Piper Aircraft Corporation
Vero Beach, Florida, U.S.A.

SERVICE No. 826A BULLETIN

(Service Bulletin No. 826A supersedes and voids Service Bulletin No. 826 dated April 10, 1986)

SUBJECT: Elevator Hinge Inspection/Replacement

SKETCH 'A'

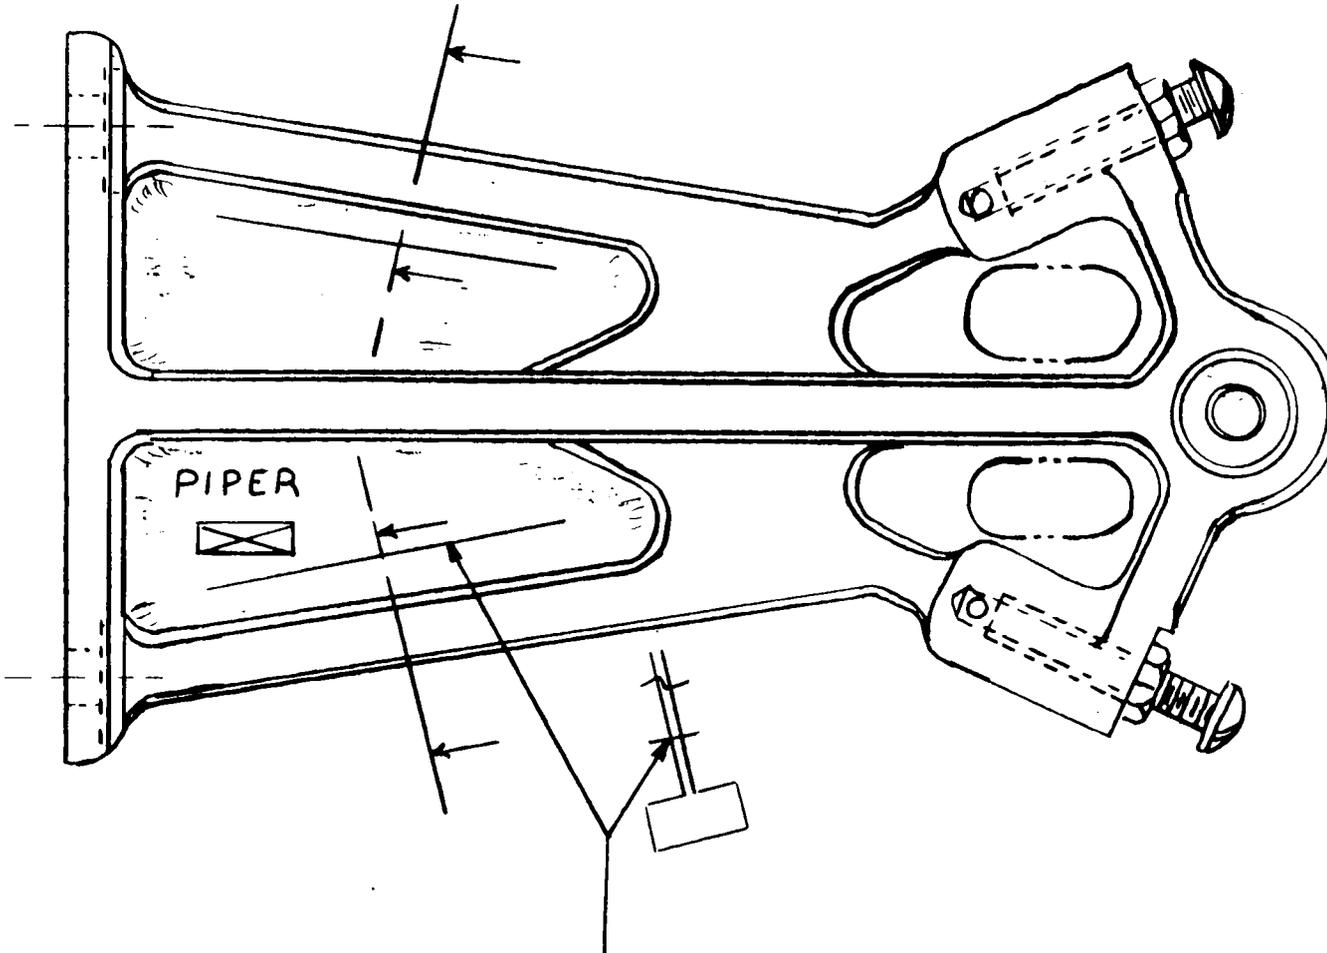
1. Gain access to the elevator center hinge by removing the upper and lower tailcone fairing assembly.
2. Remove paint and perform a dye penetrant check of the center elevator hinge in the areas indicated in Sketch "A" attached.

APPROXIMATE AREA OF CRACKS IN WEB

3. If no cracks are found, reinstall the tailcone fairing assembly and make the appropriate logbook entry. No further action is necessary.
4. If cracking is indicated by the dye penetrant check, the elevator center hinge is to be replaced and elevator stops reset in accordance with the appropriate maintenance manual.
5. Reinstall the upper and lower tailcone fairing assembly.
6. Make the appropriate logbook entry of compliance with this Service Bulletin.

MATERIAL REQUIRED: If required by inspection, one (1) each
Elevator Center Hinge, Piper Part Number 45253-03, per aircraft.
